**DOWNTOWN REVIEW BOARD
MEETING AGENDA**

FILE NO:
DRB DP 14-00004 – QUASI-JUDICIAL

PROJECT: 210 PUEBLO APARTMENTS
APPLICANT: RYAN LLOYD, ECHO ARCHITECTURE
OWNER: DOWNTOWN DEVELOPMENT GROUP, LLC

Re: Form-Based Development Plan and Warrant for 210 Pueblo Apartment Building
DRB DP 14-00004

1 SITE PLAN
 1" = 10'-0"

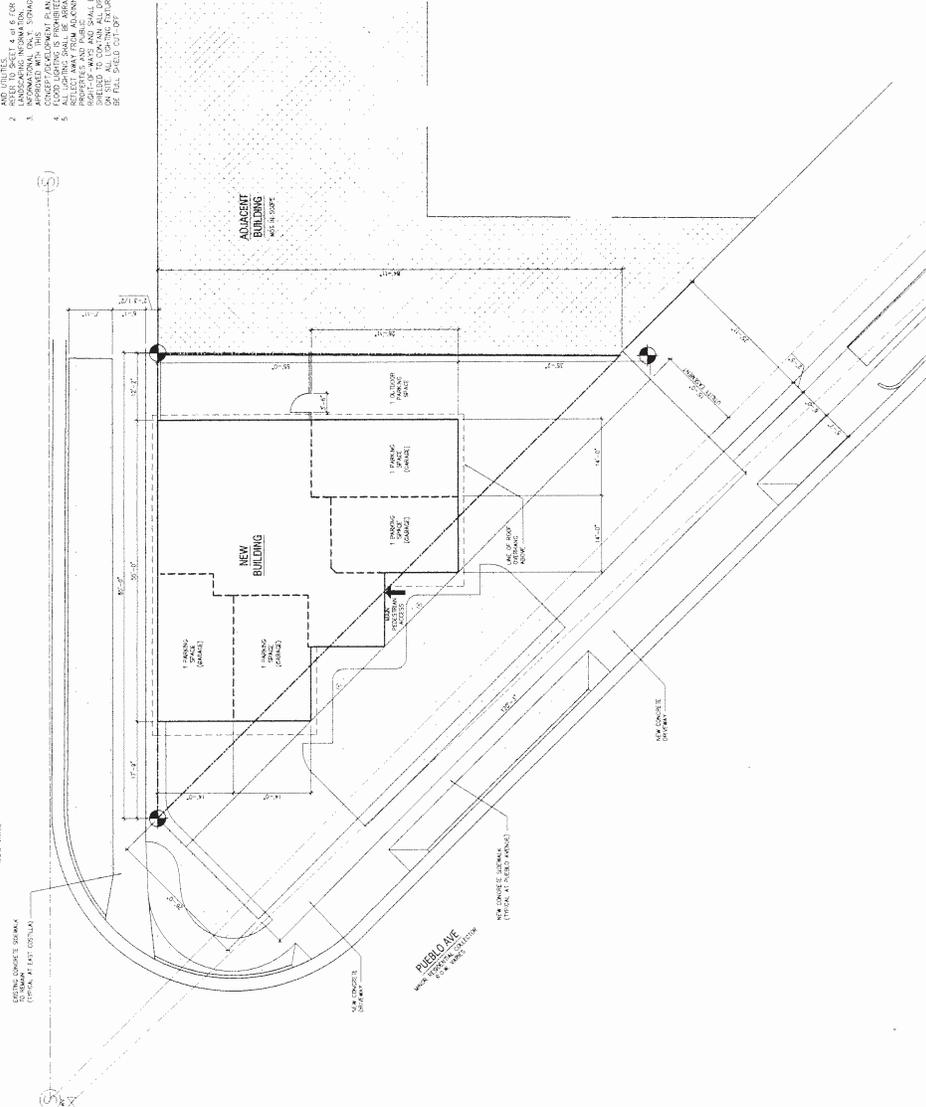
The second standard that requires relief is that a stoop frontage on an apartment building requires a minimum of 25% glazing on the first floor façade. Based on the staff's calculations, only 9% of the north-facing building façade (measured from 18 inches above grade to 10 feet above grade) is made up of glazing. The project statement justifies the request with two primary arguments: 1) because of the small lot size and need to provide adequate tenant parking, a significant portion of the proposed building's ground floor is utilized for garage parking; and 2) the limited building setback and proposed residential use necessitates fewer windows to increase security and privacy. To offset the substandard glazing, the applicant is proposing that a "three-dimensional, wall mounted art installation" be mounted to the north-facing façade. While the details of the installation are not yet defined, the plan includes a note stating that the "public art on the north (East Costilla) elevation is in the design phase. Upon completion the design will be submitted to Land Use Review and the Art Commission of the Pikes Peak Region." While the proposed art piece will certainly improve the visual appeal of the building and add pedestrian interest, staff has suggested that a second, smaller art installation, be placed on the eight-foot high screen wall at the northeast corner of the parcel to improve the appearance of the wall.

- v) Warrants – note that warrants are requested from the DRB for building envelopes (Section 2.3.3) and, glazing (Section 2.4.7.).
- d) *Scale.* Sheet 1 of the plan includes a notation on the bottom left-hand corner indicating the plan is at 1" = 1'-0" but the plan is actually at 1" = 10'

- e) *Property Lines and Easements.* Please use a more distinct line type to identify the site's property lines and easements; the plan isn't clear, particularly along Pueblo. Use of labels will also help clarify line types, setbacks, easements, and improvements.

- f) *Setbacks.* Provide a label documenting the proposed building setbacks along Pueblo, Costilla, and the eastern property line.
- g) *Existing Trees.* Document the presence or absence of existing trees; label public trees to be removed.

- j) *Revocable Permit.* It appears as if a revocable permit will be necessary to allow the roof overhang to project into the Costilla right-of-way. Please submit the necessary permit application and fee. Add a note to the plan referencing the revocable permit.

1 EAST EXTERIOR ELEVATION
1/4" = 1'-0"

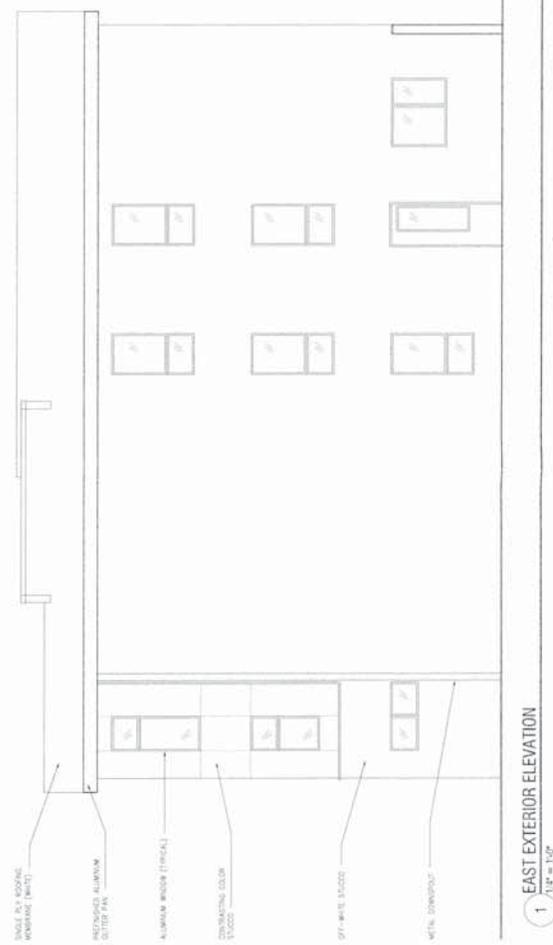
8. Add additional art, architectural treatment, or varied materials to the eight-foot high screen wall at the northeastern portion of the site.
 9. Add a concrete transit pad along Costilla to serve the existing bus stop.

- k) *Trash.* Is a trash enclosure proposed? How will trash be managed?
- l) *Elevations.* Document the height of the screenwall at the northeast corner of the site. Staff suggest that this portion of the north elevation be improved with additional art, materials, or texture to help justify the glazing warrant.
